PLANNING DIRECTOR'S SPECIAL PERMIT
1231 "I" STREET, SUITE 200, SACRAMENTO, CA 95814

APPLICATION: Planning Director's Special Permit to construct a second residential unit on a deep lot in the Single Family (R-1) zone.

PROPOSAL: The applicant is requesting the necessary entitlements to construct a second unit on a deep lot in the Single Family (R-1) zone.

APPLC. NO. P91-168

WEST ELEVATION

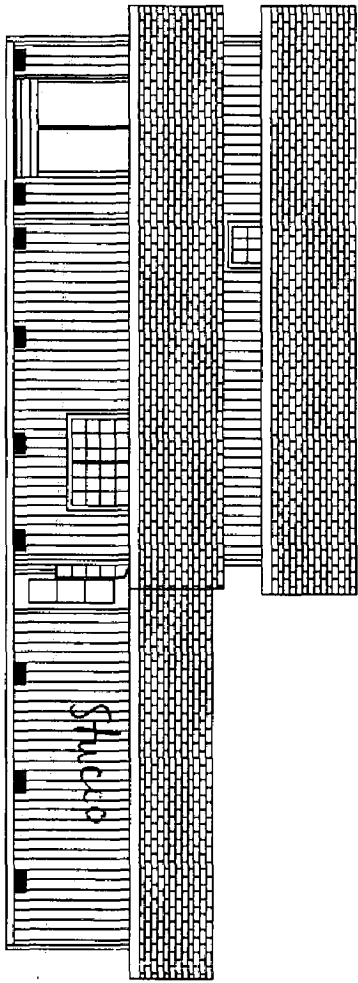
B. The west elevation should have the following:

1. Stucco siding on the garage portion with brick three feet high.

NORTH ELEVATION

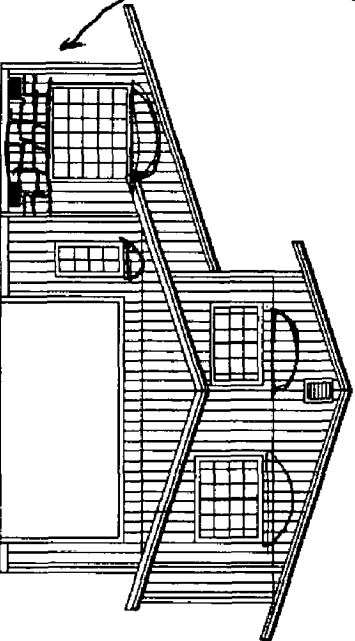
A. The north elevation should have the following:

1. stucco siding,
2. all the windows should be girded with the trim and sill matching the existing house.
3. The lower three feet of the north elevation should have brick with brick columns on either side of the garage.
4. The garage door should be a metal sectional door with raised panel design.
5. The exterior paint should be compatible with the existing house.
